ADDENDUM 1

PROJECT NAME: APACHE CREEK LINEAR PARK LIGHTING UPGRADES

DATE: September 11, 2020

PROJECT NO: 29652000

SHEET:
ES1.4B

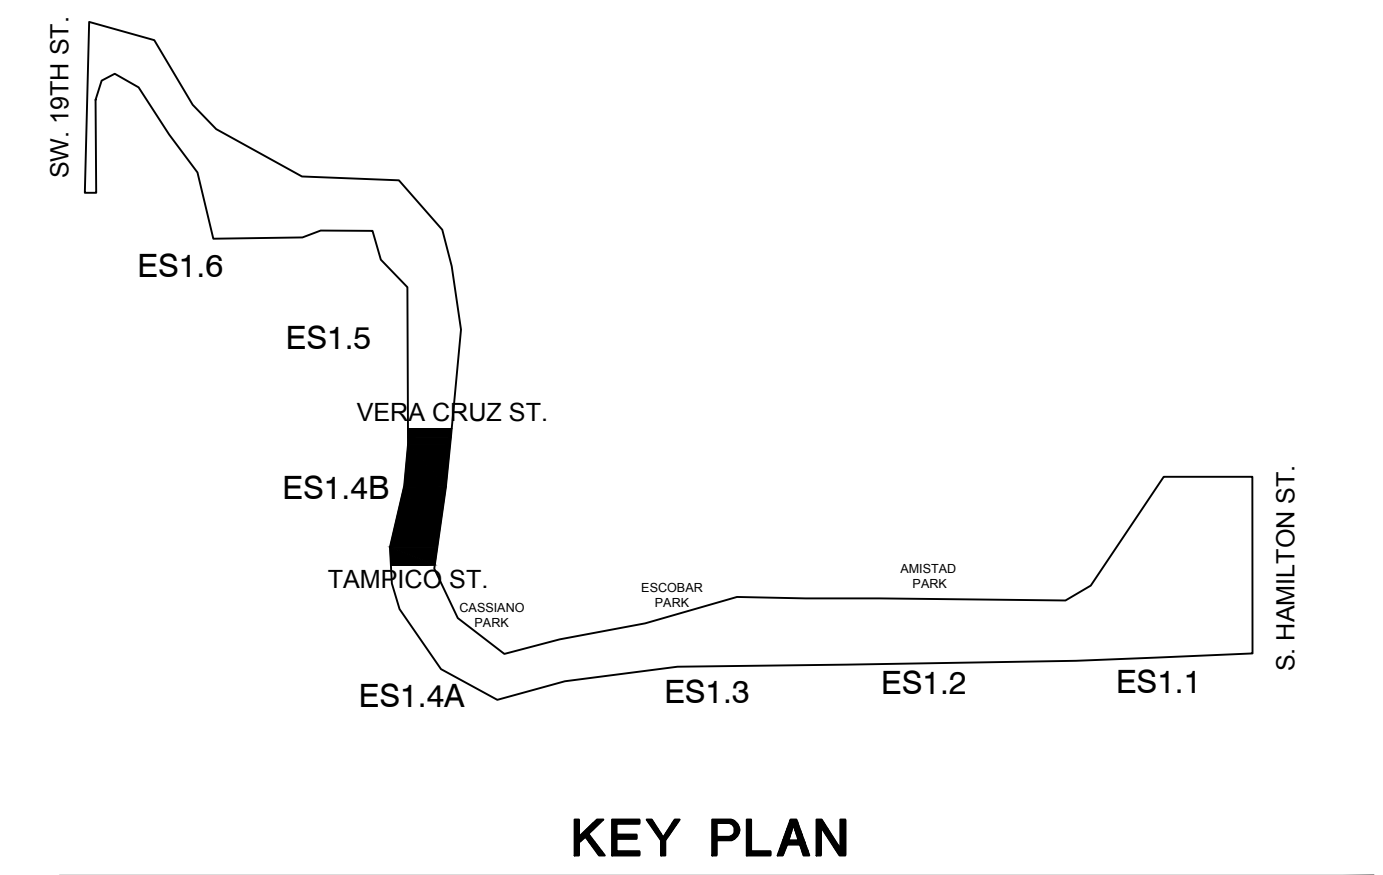
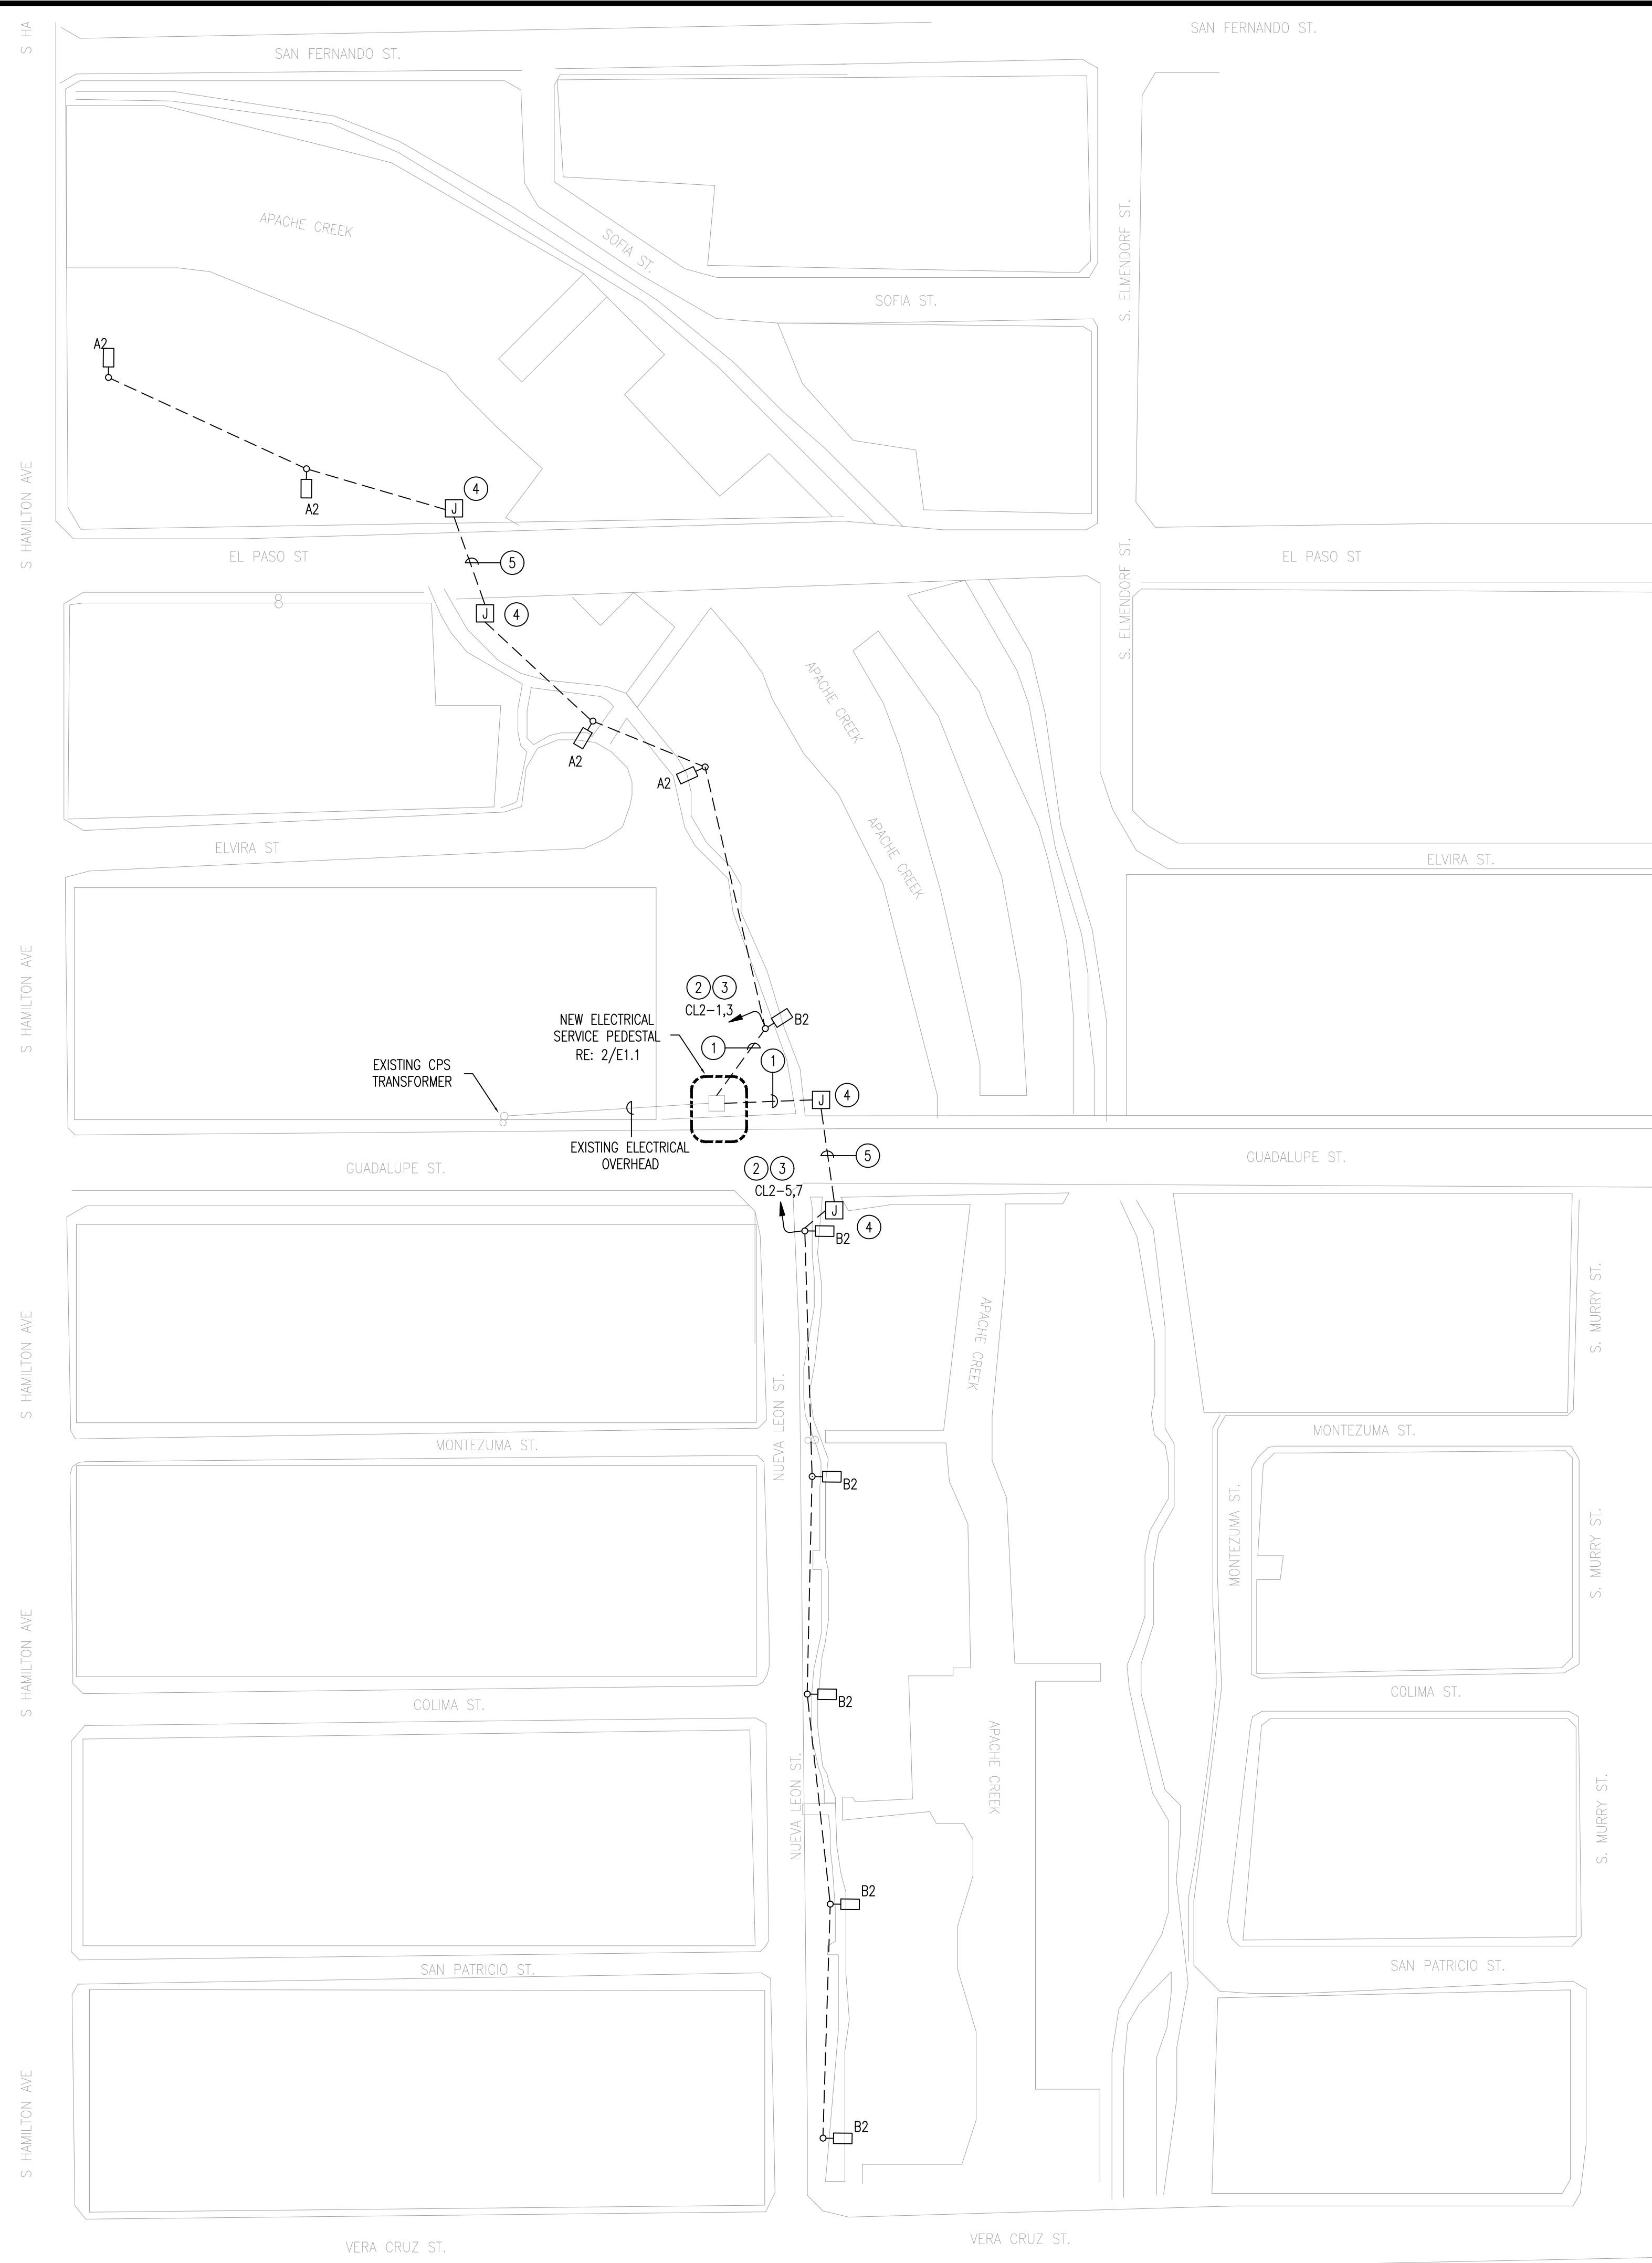
- xi. RE: Plan Sheet ES1.4A:
 - a. Item 1: Added note to contractor regarding pole base location, as indicated.
- xii. RE: Plan Sheet ES1.4B:
 - a. Item 1: Added note to contractor regarding pole base location, as indicated.

- PROVIDE CONDUIT(S) FOR CIRCUITRY, AS INDICATED. COORDINATE ROUTING WITH ENGINEER(S) PRIOR TO TRENCHING TO AVOID CONFLICTS WITH ANY FIELD ITEMS.
- PROVIDE (1) 1" CONDUIT FOR LIGHTING CIRCUIT WITH (2)#8 AWG CU, AND (1)#8 GND.
- ROUTE CIRCUIT THRU LIGHTING CONTACTOR/TIMECLOCK ASSEMBLY.

SHEET:
ES1.6

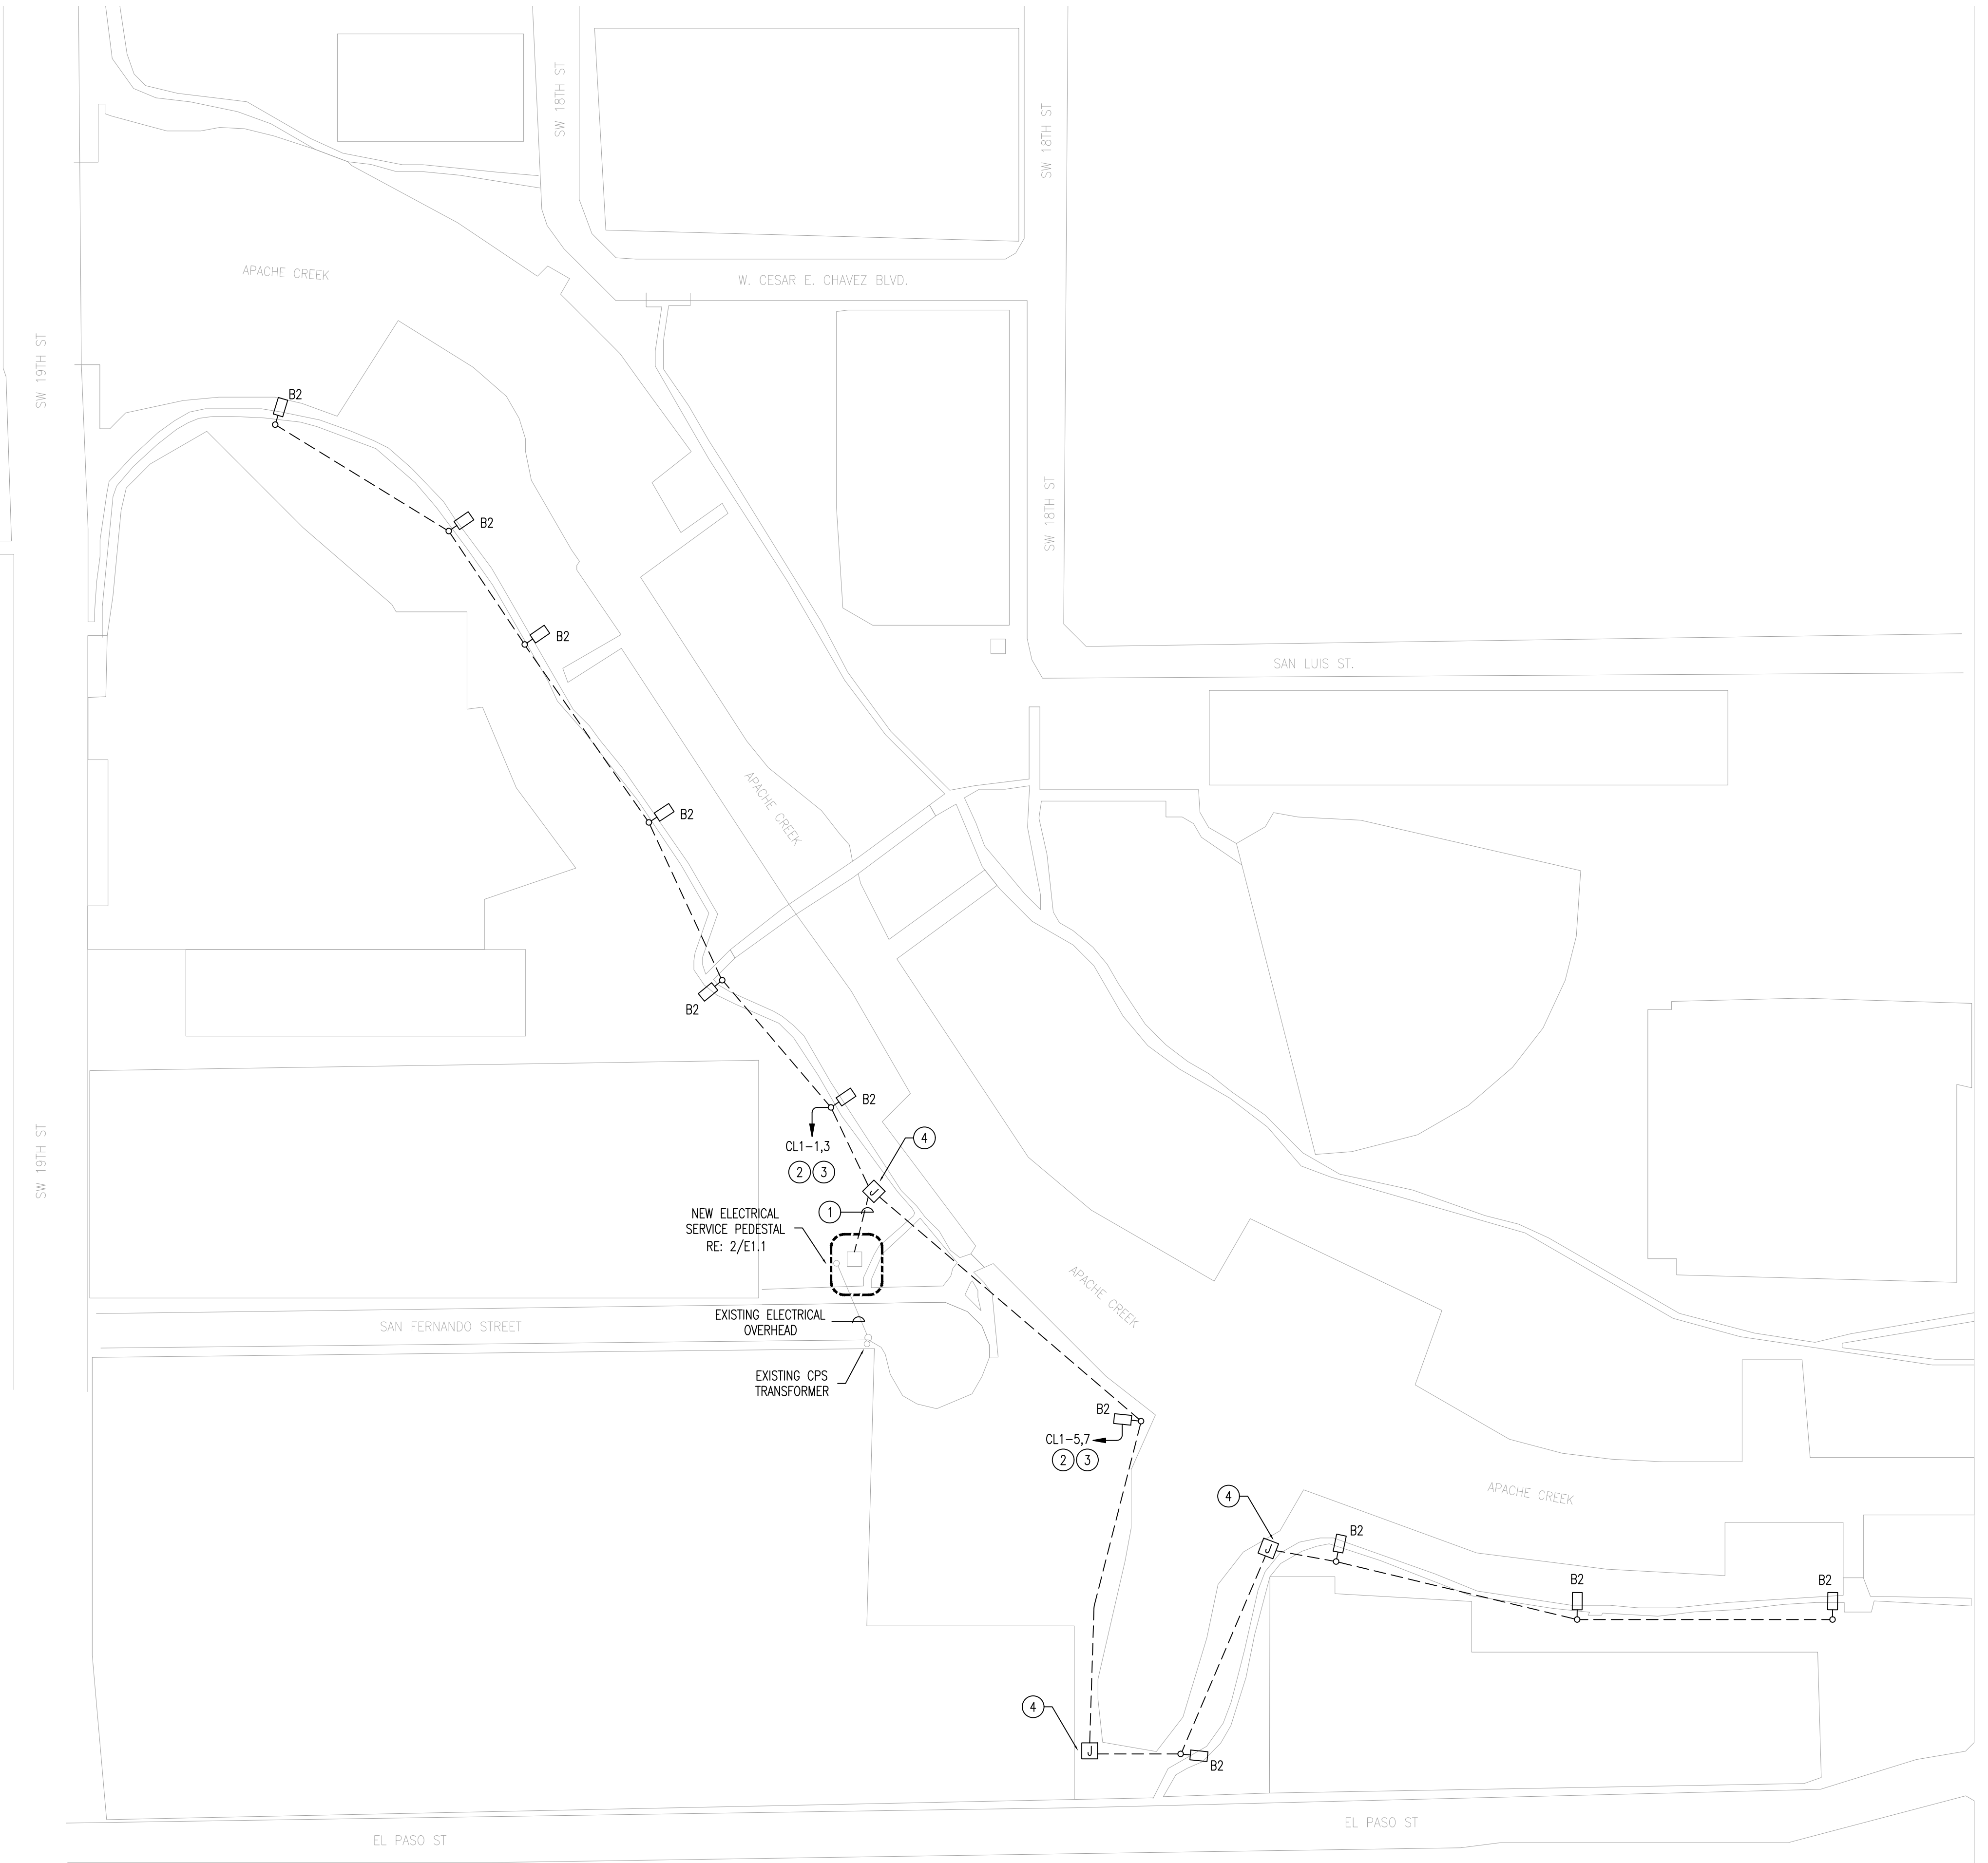
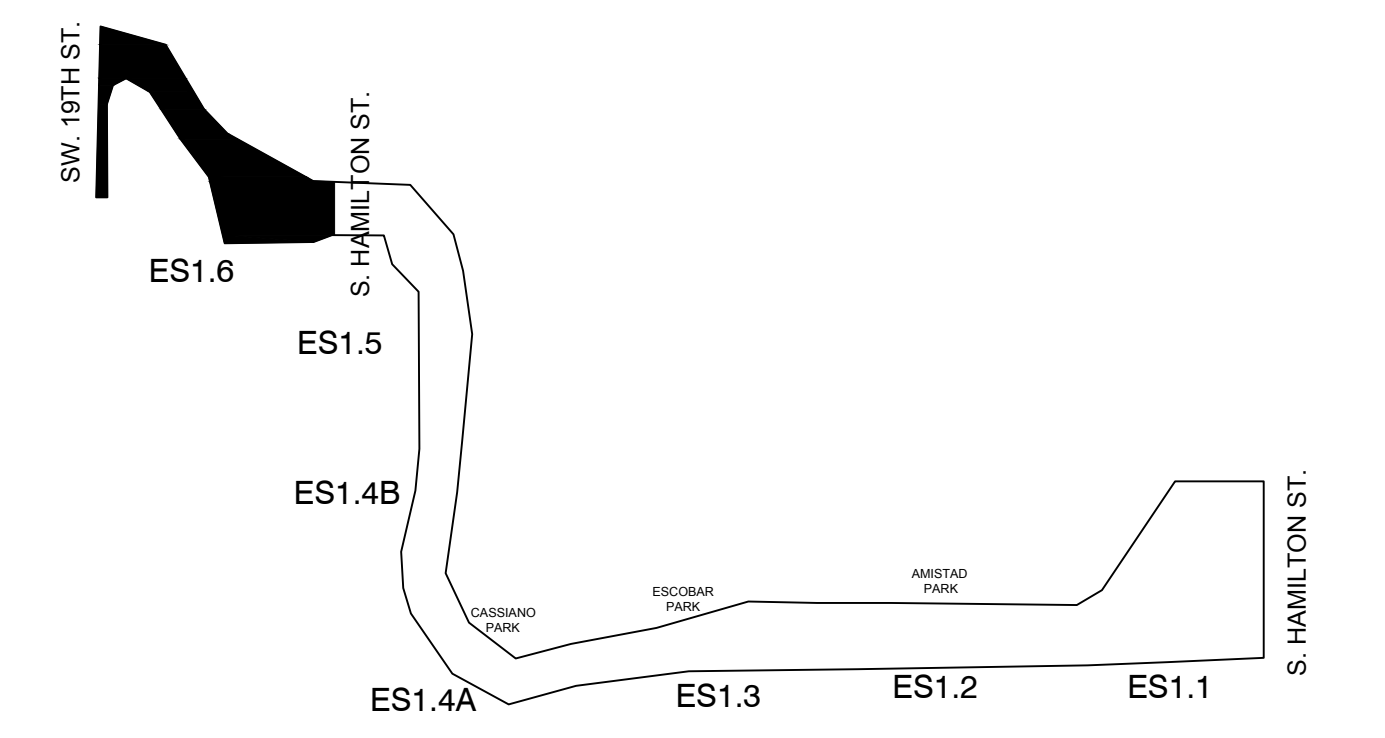
- a. Item 1: Added note to contractor regarding pole base location, as indicated.

1. PROVIDE CONDUIT(S) FOR CIRCUITRY, AS INDICATED. COORDINATE ROUTING WITH ENGINEER(S) PRIOR TO TRENCHING TO AVOID CONFLICTS WITH ANY FIELD ITEMS.
2. PROVIDE (1) 1" CONDUIT FOR LIGHTING CIRCUIT WITH (2)#8 AWG CU, AND (1)#8 GND.
3. ROUTE CIRCUIT THRU LIGHTING CONTACTOR/TIMELOCK ASSEMBLY.
4. PROVIDE IN-GROUND PULL BOX. COORDINATE LOCATION WITH ENGINEER(S) PRIOR TO ROUGH-IN TO AVOID ANY CONFLICTS WITH ANY FIELD ITEMS.
